TECHNICAL NOTE

JBA Project Code	2019s0875
Contract	Dragons Parc
Client	Huntley Wood Investments Ltd.
Day, Date and Time	06/07/2020
Author	Jonathan King MEng PhD
Reviewer / Sign-off	George Baker BEng AIEMA CEnv IEng MCIWEM C.WEM
Subject	Hydraulic Model Update

This document forms an addendum to the FCA and describes minor changes made to the development proposals and hydraulic model to address the concerns raised by DCWW.

Figure 2-1: Proposed swale and reprofiling and planning boundaries (original planning application)

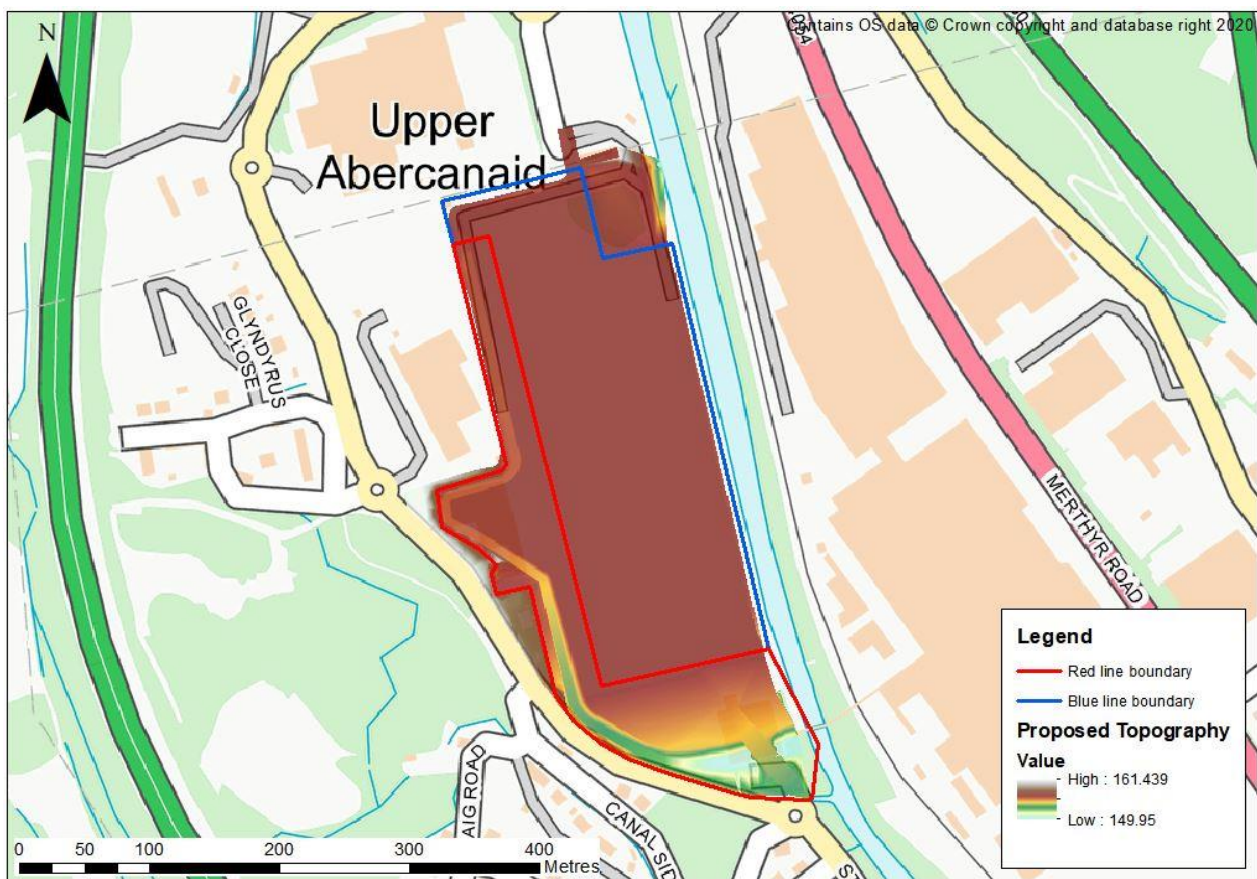
On reviewing the planning application DCWW objected to the scheme on the basis of ground raising in the southern section of the site, within which a water distribution trunk main is located. The originally submitted design showed ground levels above the DCWW water distribution trunk main as being raised by approximately 1m. As the water main is already at depth, DCWW raised concerns that the additional depths would make it hard from them to maintain the asset in the future.

The proposed ground raising over the water main, with the exception of the access road, is not essential to the flood risk work, but was included in the design to smooth out some of the topography in the southern portion of site where existing ground levels change rapidly. Consequently, the design has been amended to remove, with the exception of the access road, any ground raising over the water main. This decision does not prejudice future site development proposals which will be subject to a separate design process.

To address DCWW's concerns, the southern area within which the water main lies has been reprofiled to 155.6mAOD. This aligns with the existing ground level above the water main whilst still preventing flooding of the area in the 0.1% AEP fluvial flood event.

Figure 2-2: TUFLOW model files pertinent to the ground level modifications and Z-shape attributes; levels in mAOD, widths in m

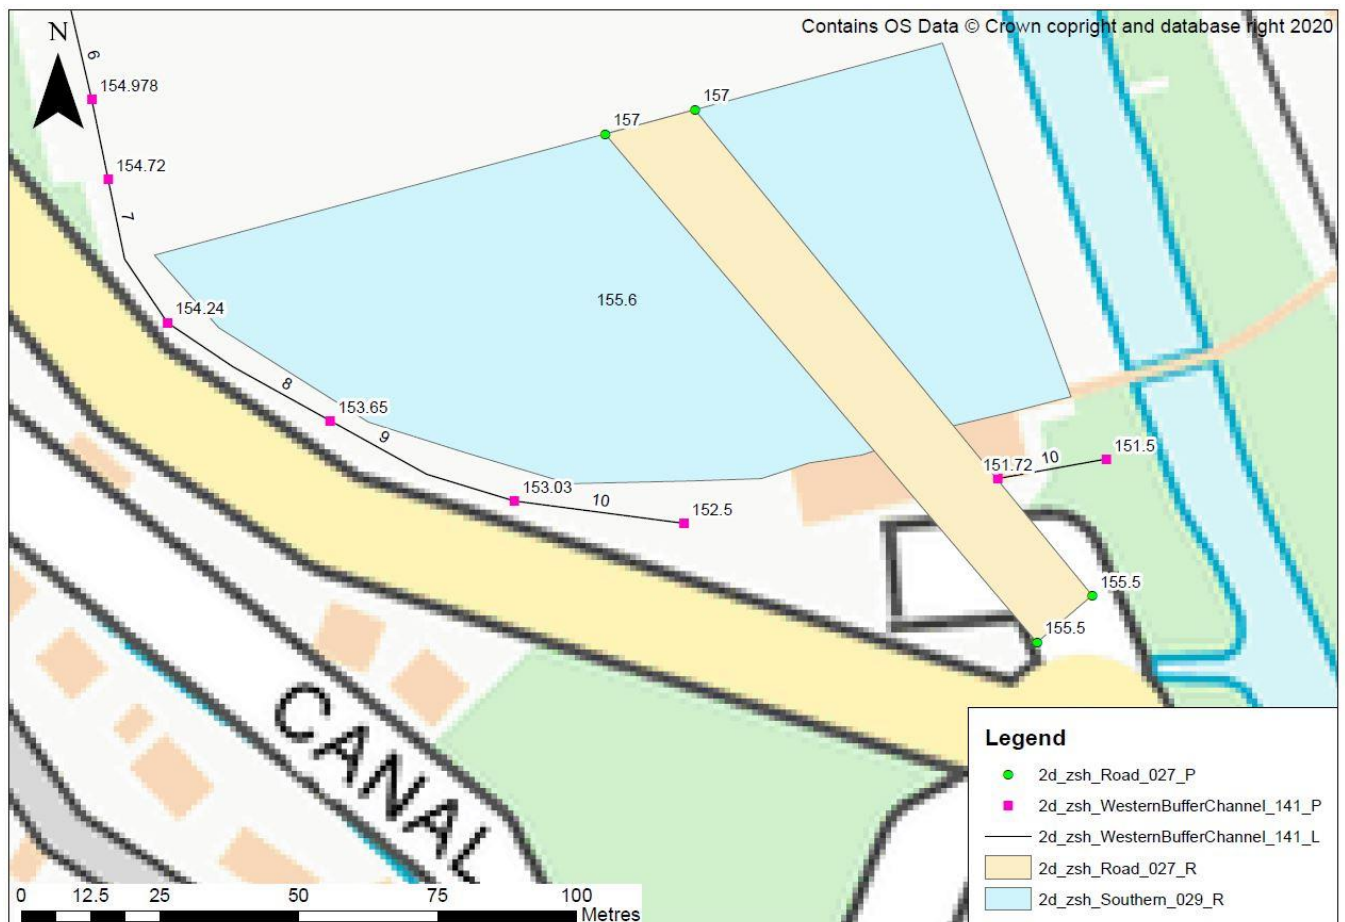
In addition, minor adjustments to the swale gradient and width have been made to increase the capacity of the swale in the vicinity of the water main. Amended model files are described in Table 2-1 and Figure 2-2.

Figure 2-3: TUFLOW Z-shape check file

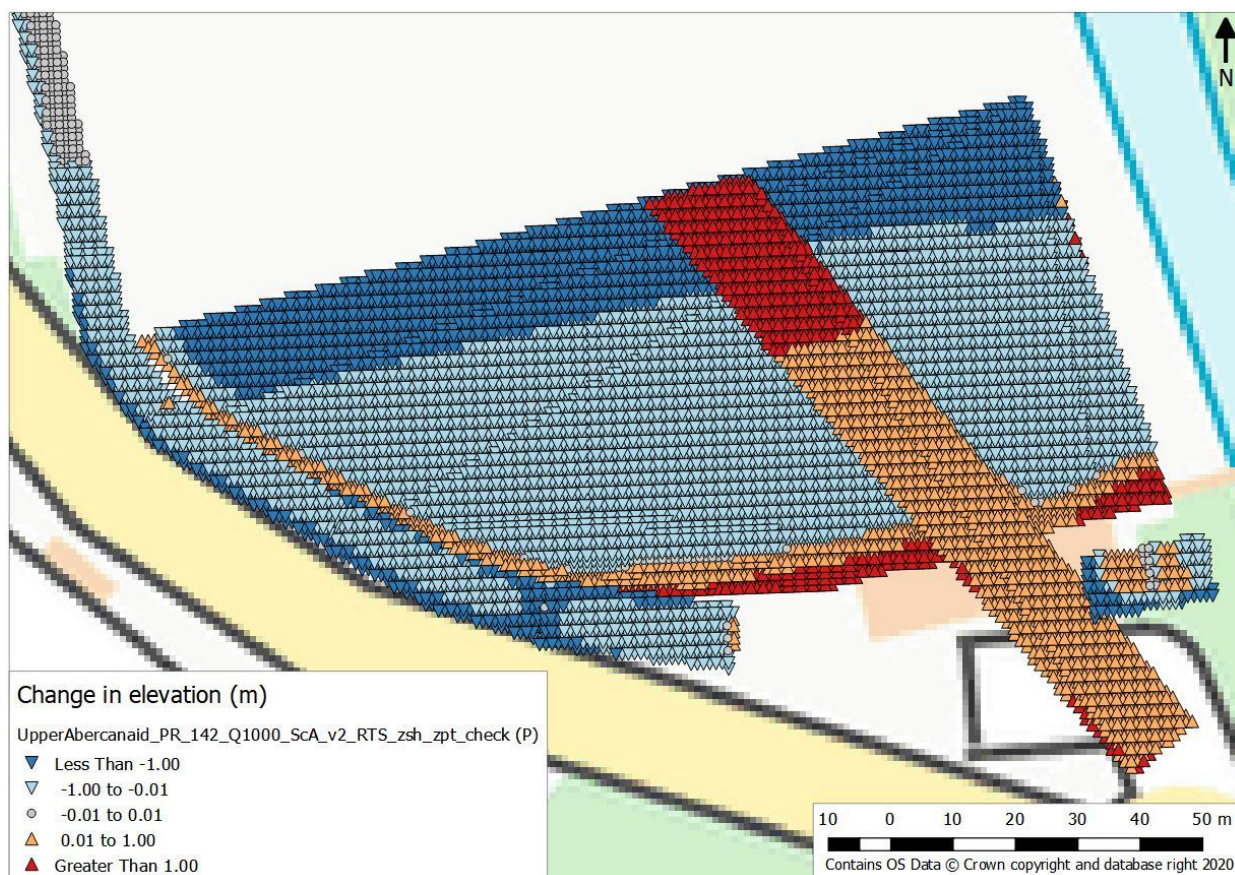
Figure 2-3 and 2-4 show the changes in level between the proposed ground level as per the submitted planning application (PR_128) and the updated model (PR_142).

Figure 3-1: 1% AEP water level comparison

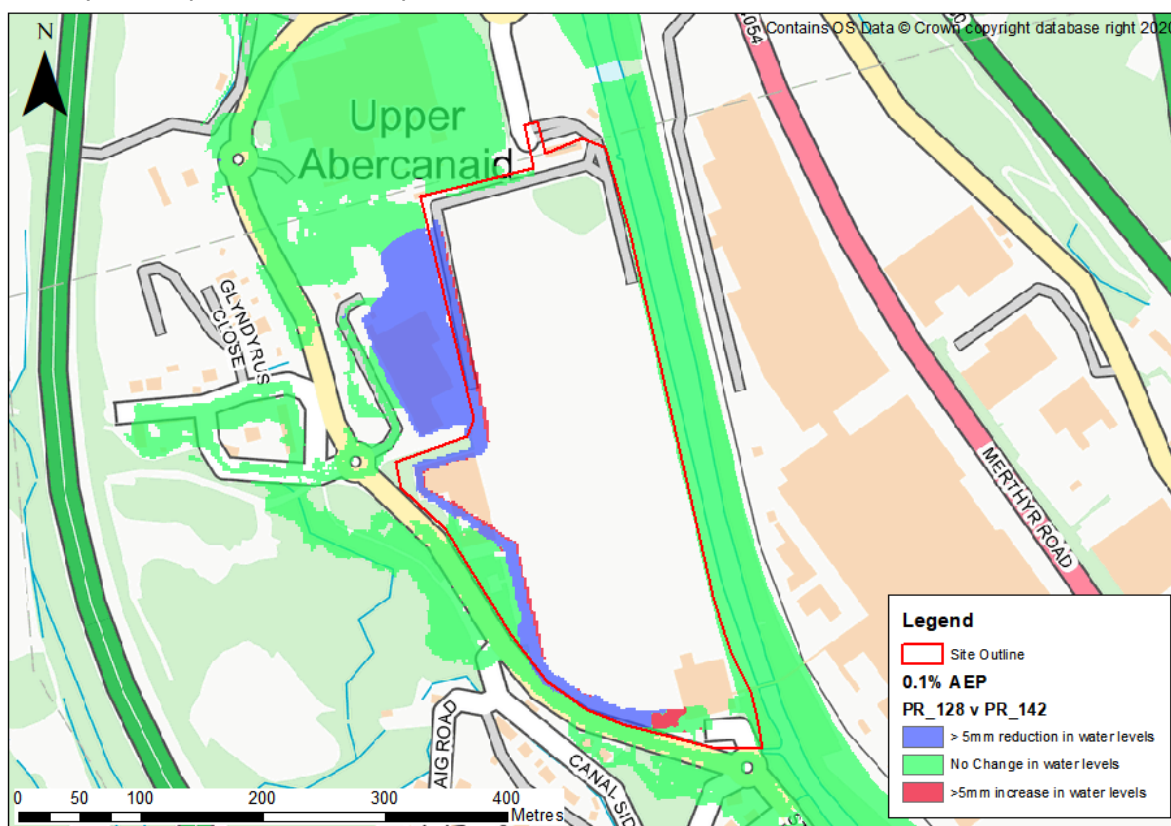
A comparison of maximum water levels between the model submitted with the original planning application (PR_128) and the updated model (PR_142) is shown in Figure 3-1 for the 0.1% AEP event.

The updated configuration results in lower in-channel water levels and does not cause any detriment outside of the site boundary. There is an increase of 17mm in the maximum water level upstream of the box culverts due of the increased channel conveyance upstream of this point.
